**STATE OF HAWAII
DEPARTMENT OF TRANSPORTATION
HIGHWAYS**

**ADDENDUM NO. 2
FOR
KUHIO HIGHWAY RESURFACING
WAIKAEA BRIDGE TO MAILIHUNA ROAD
FEDERAL-AID PROJECT NO. NH-056-1(063)
DISTRICT OF KAWAIHAU
ISLAND OF KAUAI
April 27, 2023**

This Addendum makes the following amendments to the Bid Documents:

△ D3-1-10
Not to Scale

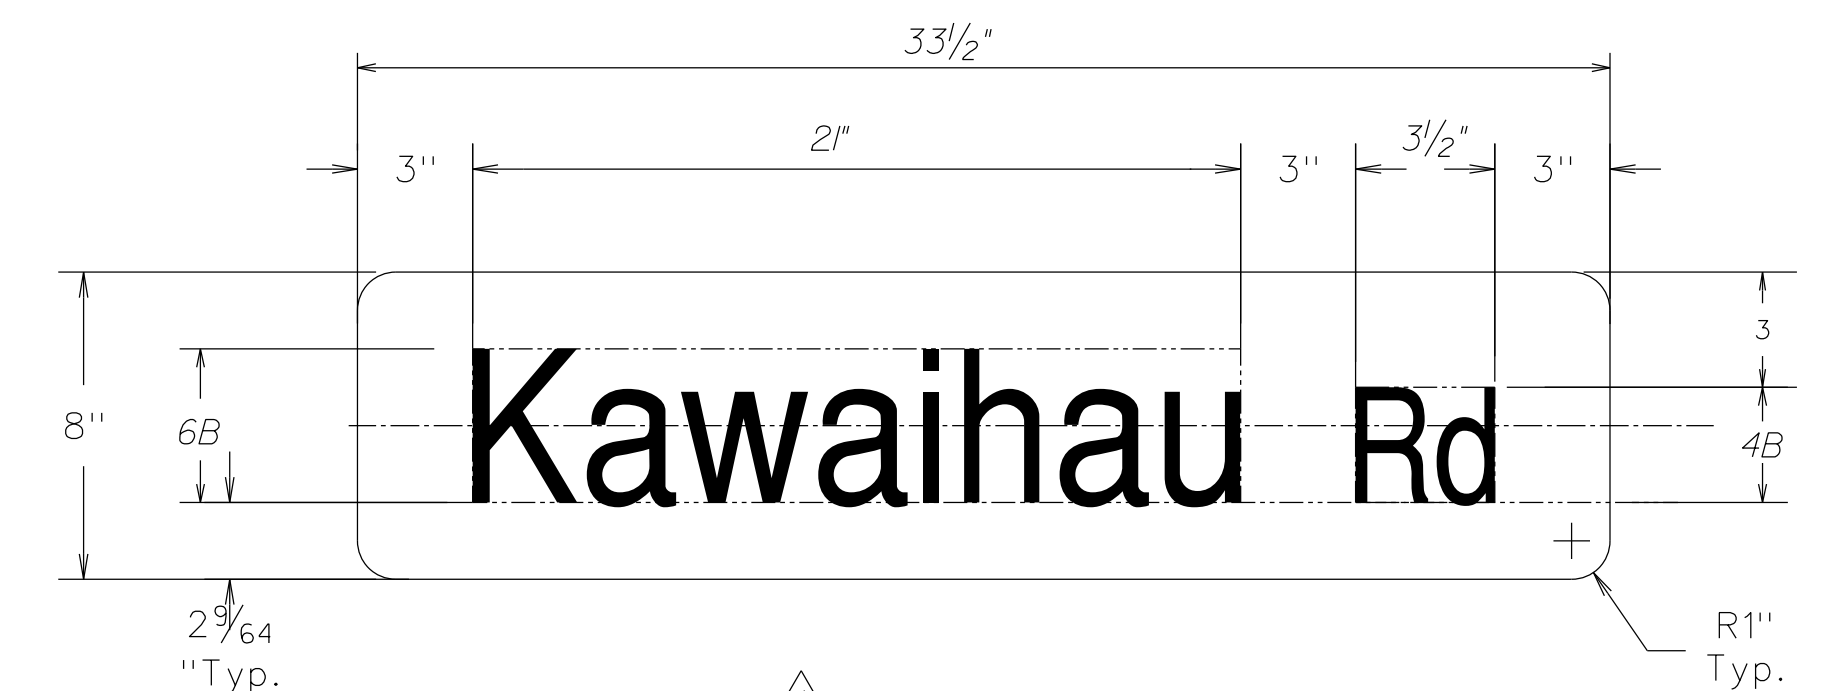
4/21/23	△ - Revise D3-1-10
DATE	REVISION
STATE OF HAWAII DEPARTMENT OF TRANSPORTATION HIGHWAYS DIVISION	
<u>SIGN DETAIL</u>	
KUHIU HIGHWAY RESURFACING Waikaea Bridge to Mailihuna Road Federal-Aid Project No. NH-056-1(063)	
Scale: As Noted	Date: April 2023
SHEET No. 1 OF 4 SHEETS

FED. ROAD DIST. NO.	STATE	FED. AID PROJ. NO.	FISCAL YEAR	SHEET NO.	TOTAL SHEETS
HAWAII	HAW.	NH-056-1(063)	2023	ADD.41	43

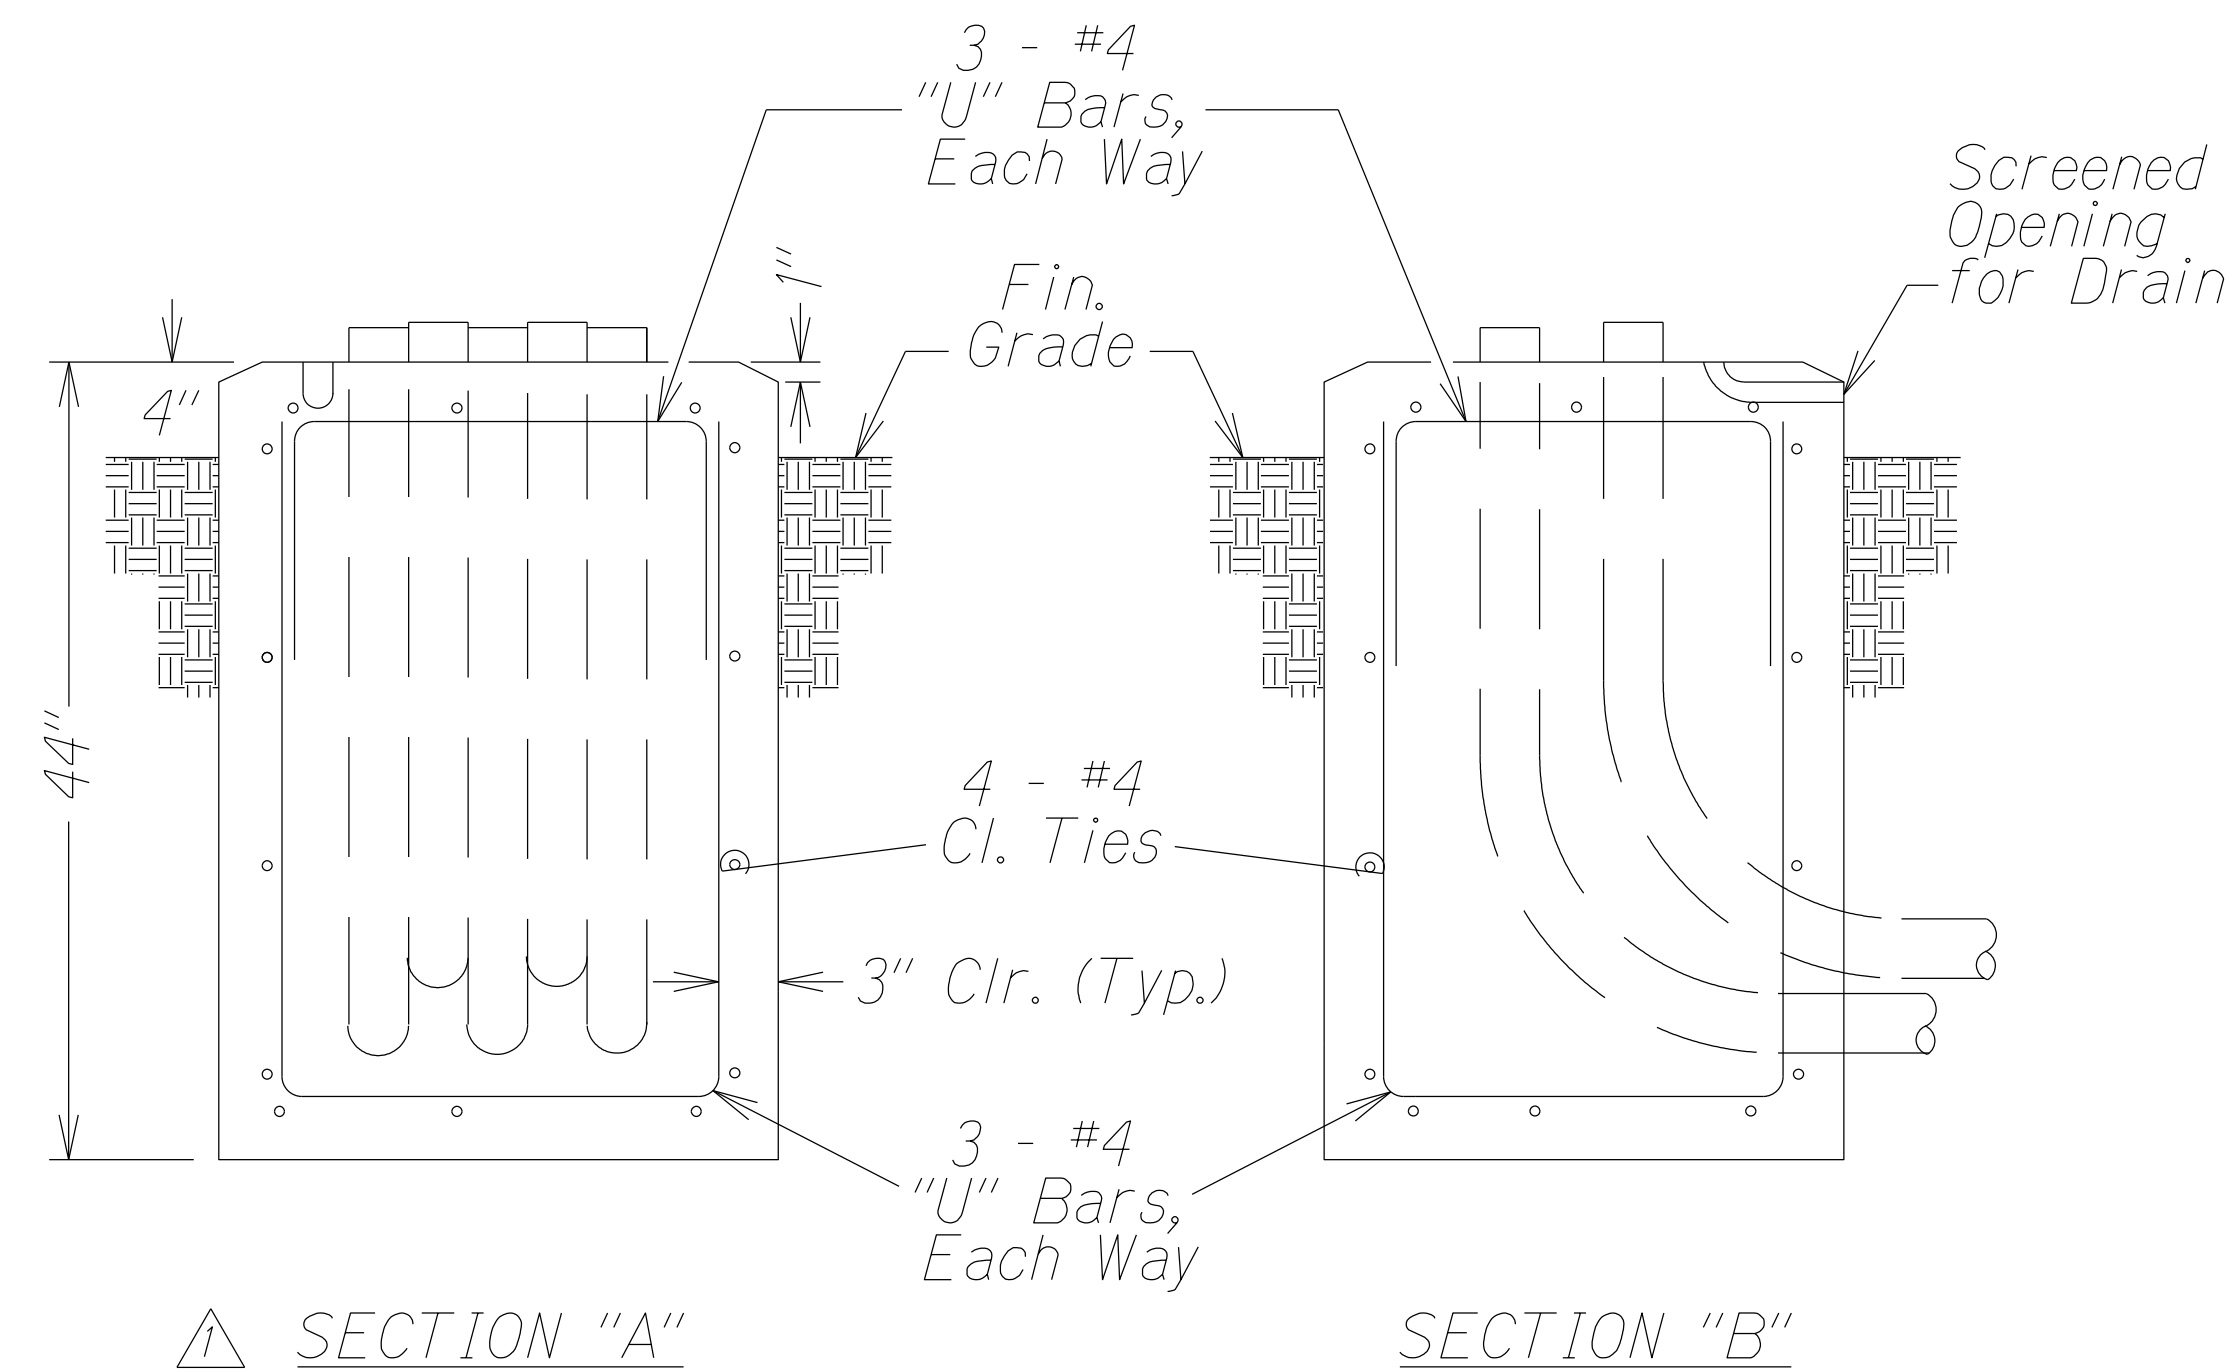
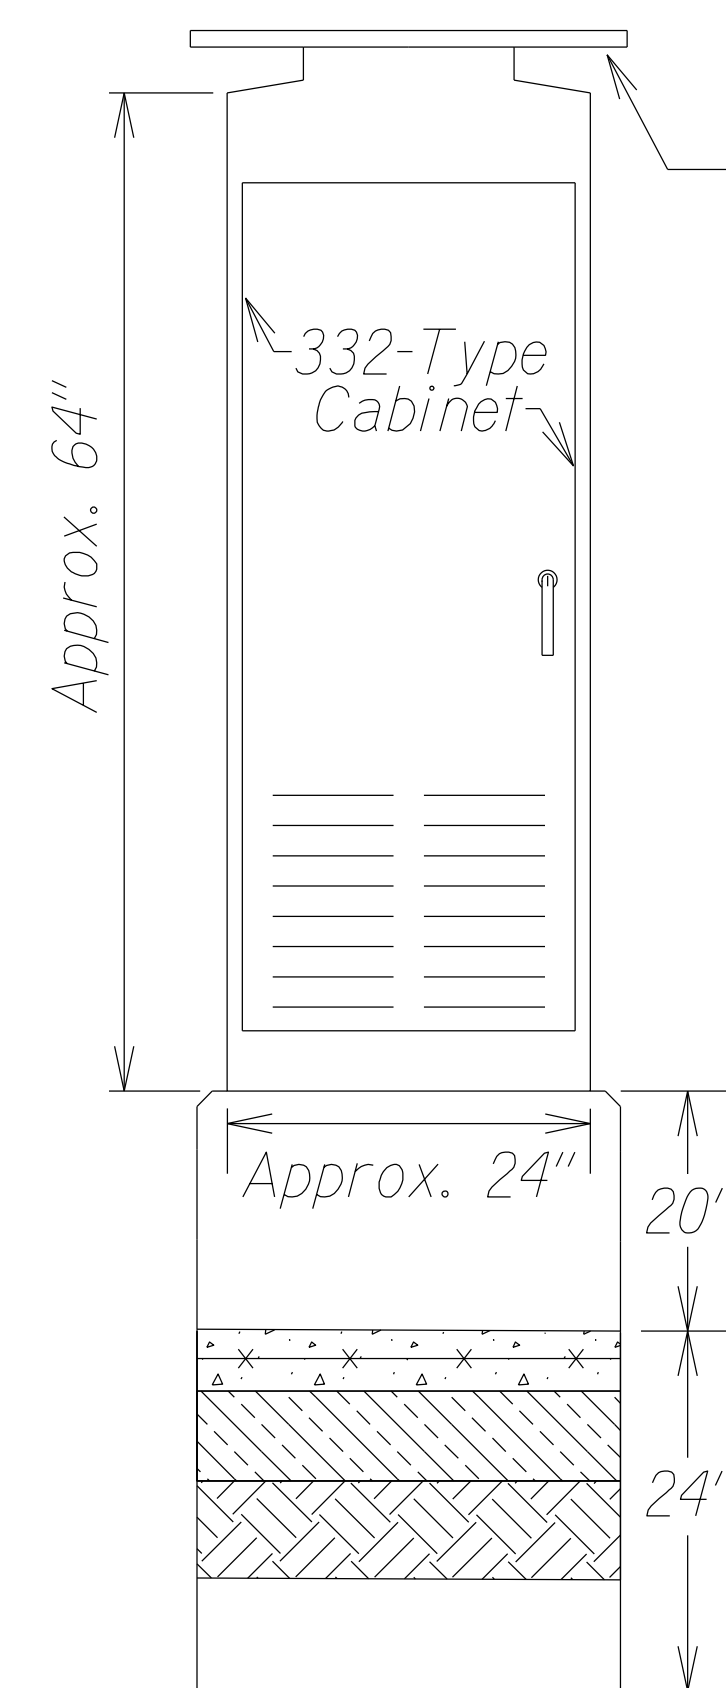
DATE	REVISION
4/21/23	△ - Revise Section "A"
4/21/23	△ - Revise Front View
